H. B. ROBINSON STEAM ELECTRIC PLANT, UNIT NO. 2
TECHNICAL SPECIFICATIONS CHANGE REQUEST TO CONVERT TO THE
IMPROVED STANDARD TECHNICAL SPECIFICATIONS

SUPPLEMENT 4

SUPPLEMENT 4
CONVERSION PACKAGE SECTION 1.0
PAGE INSERTION INSTRUCTIONS

Figure 2.1.1-1 (page 1 of 1)
Reactor Core Safety Limits

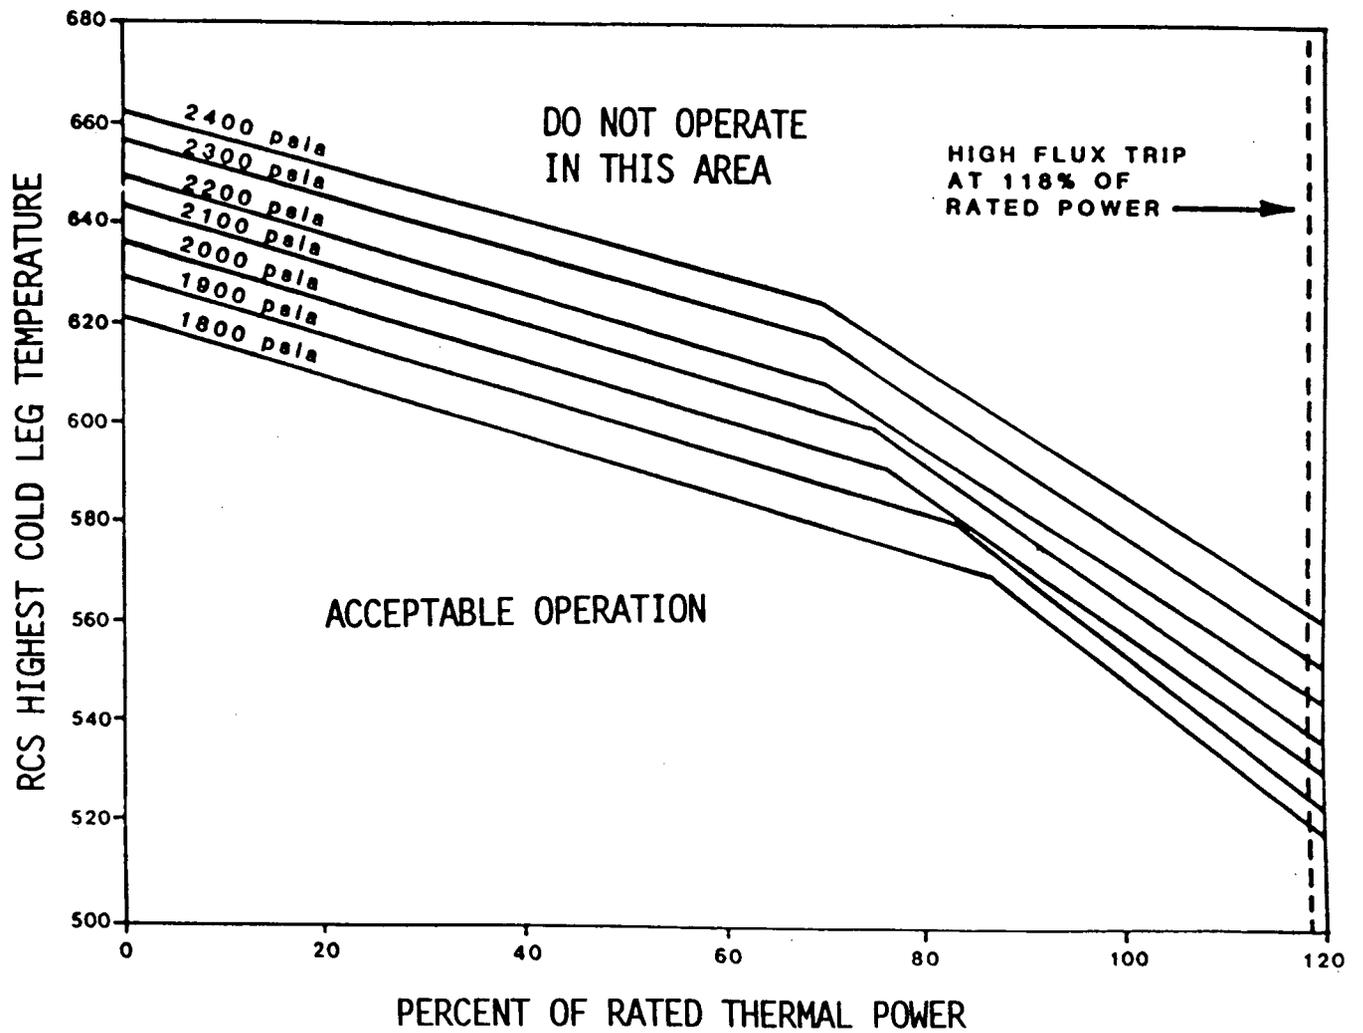
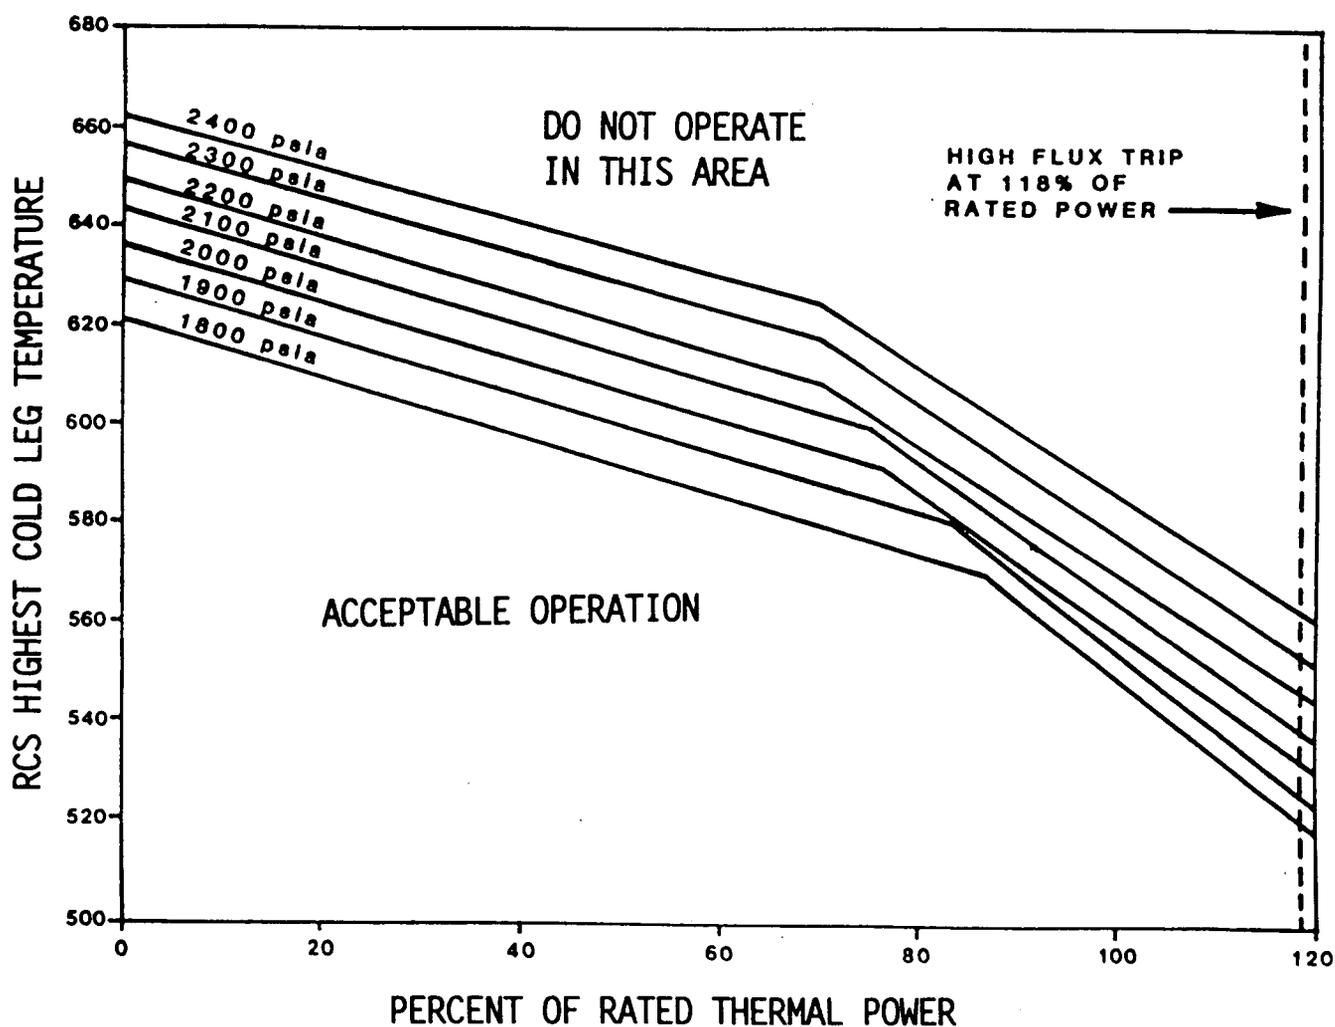
- A4 CTS Figure 2.1-1 does not clearly define the regions of acceptable and unacceptable conditions. Administrative clarifications are included in ITS to delineate the appropriate regions on the figure. This change is consistent with NUREG-1431.

NOTE: BASED ON A MINIMUM RCS FLOW OF 97.3×10^6 lbm/hr
